Shunde Place

2021 July Version

First Floor Plan

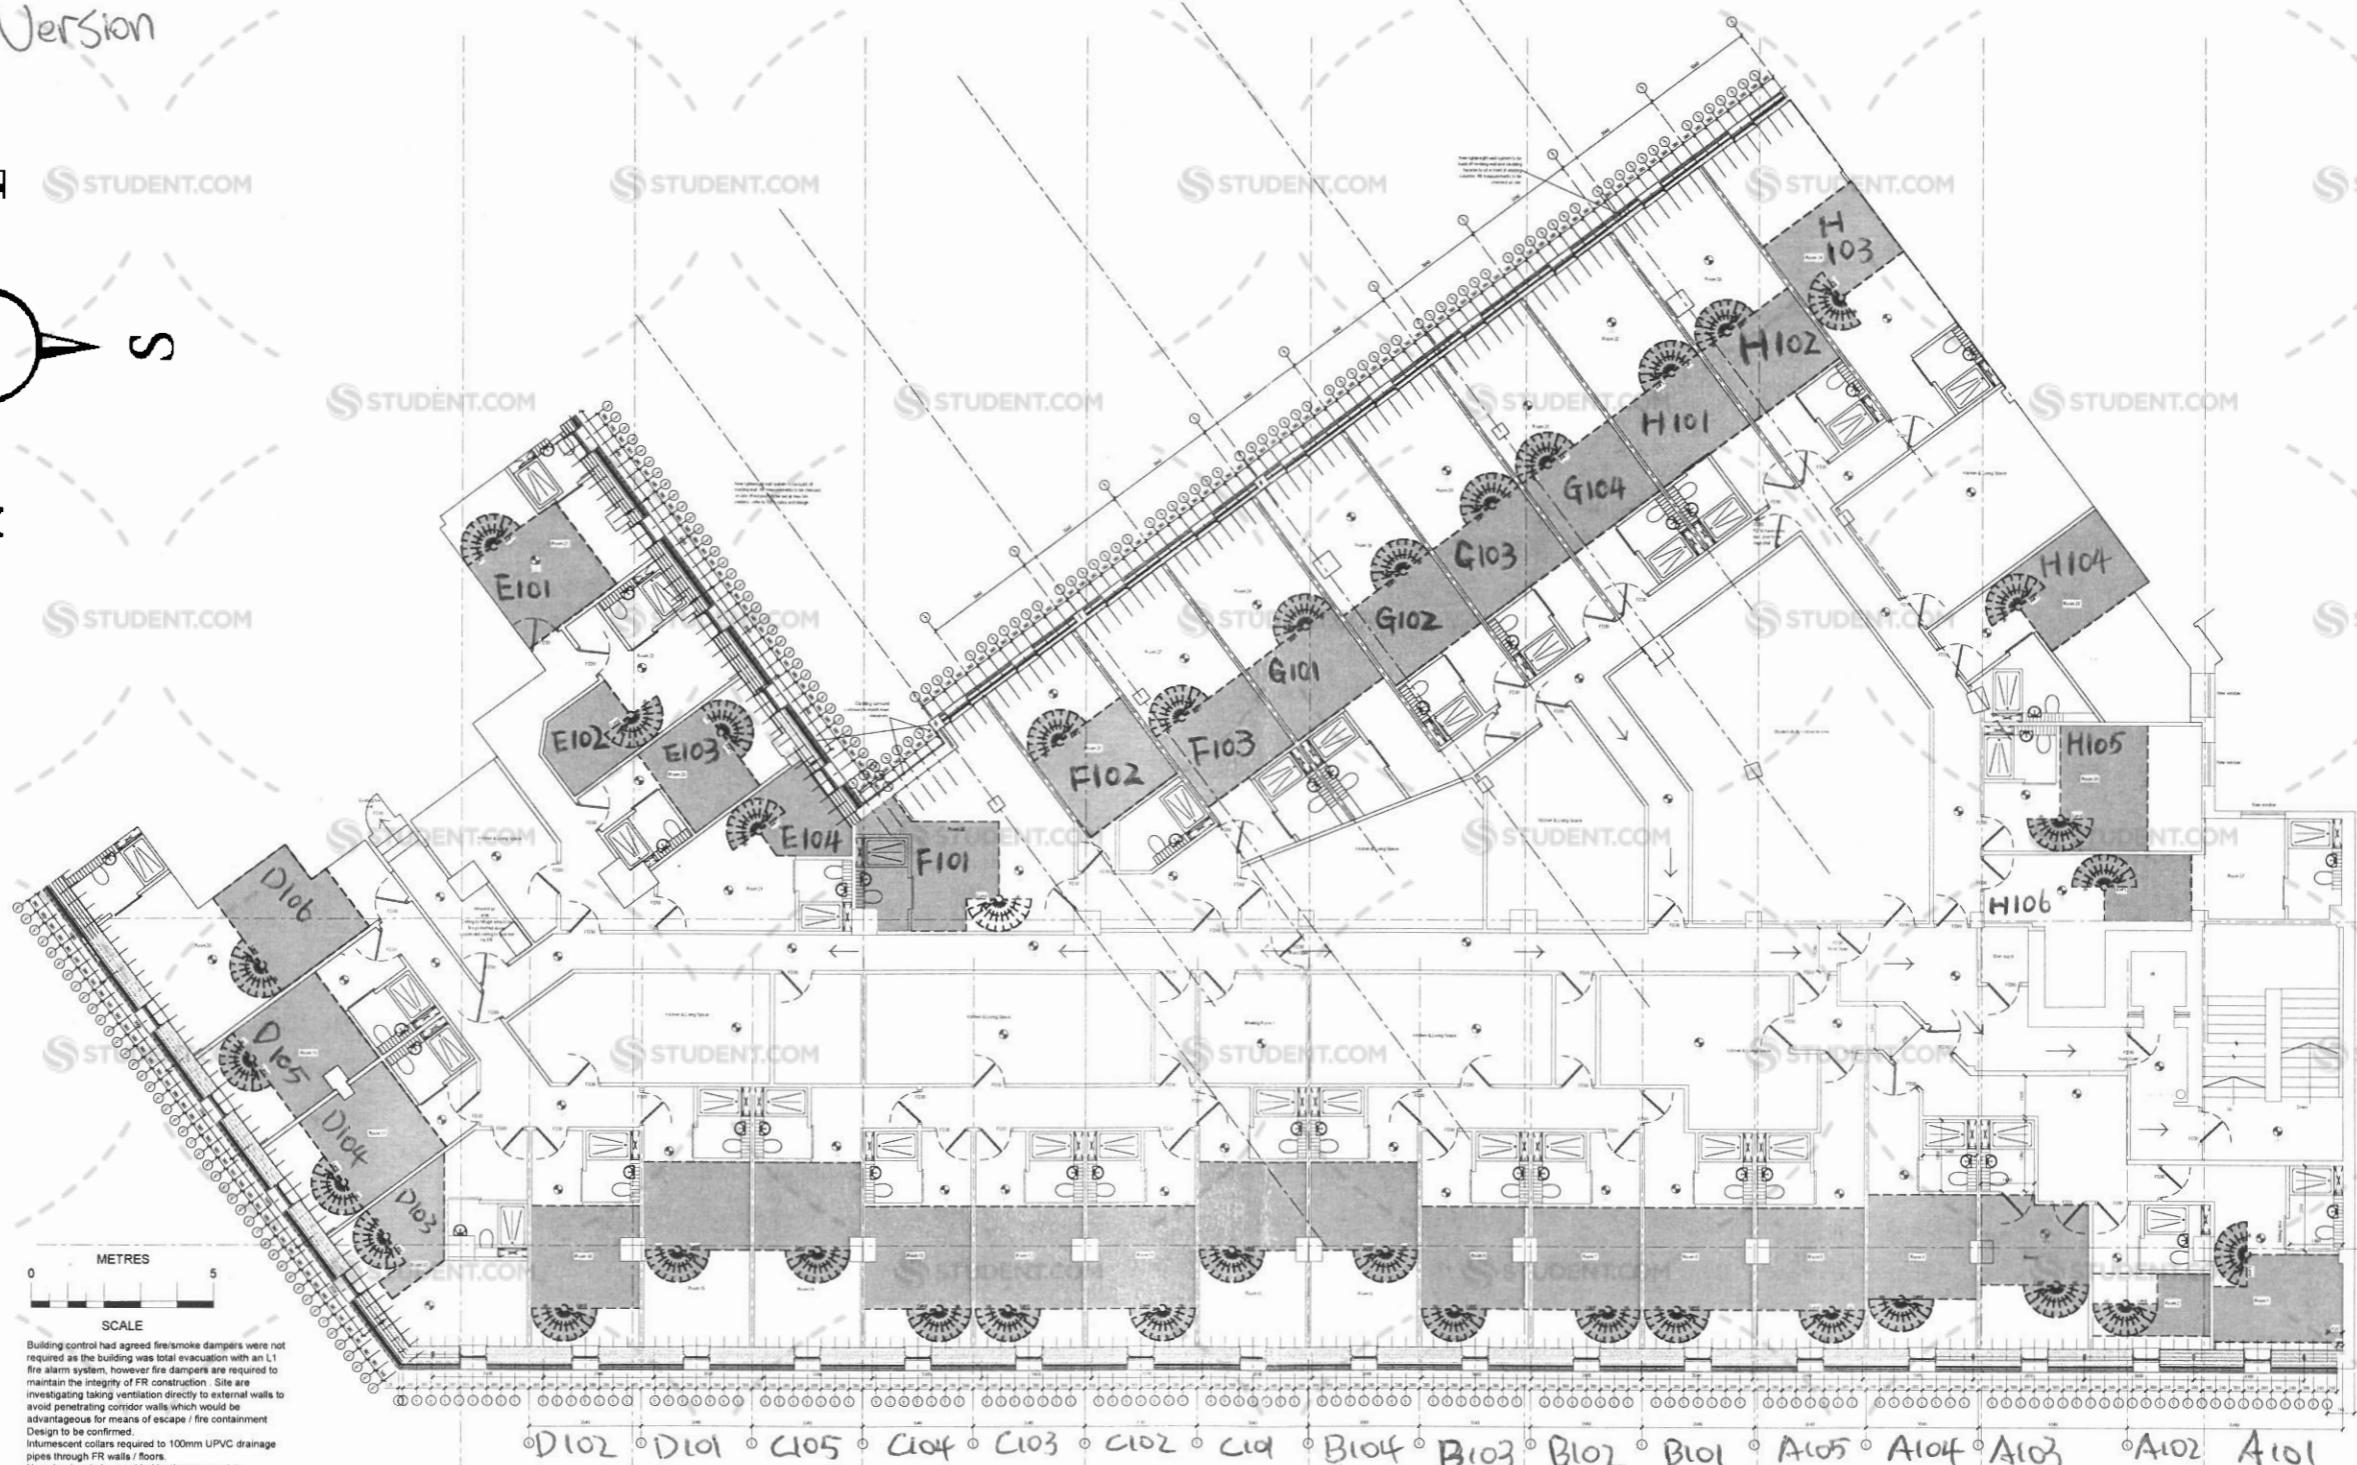
Building control had agreed fire/smoke dampers were no longer required as building was total evacuation with an L1 fire alarm system, however fire dampers are required to monitor the integrity of FR construction. Site are investigating taking ventilation directly to external walls to avoid penetrating corridor walls which would be advantageous for means of escape / fire containment  
Design to be confirmed  
Intumescent collars required to 100mm UPVC drainage pipes through FR walls / floors.  
New dry riser to be provided by the access stair.
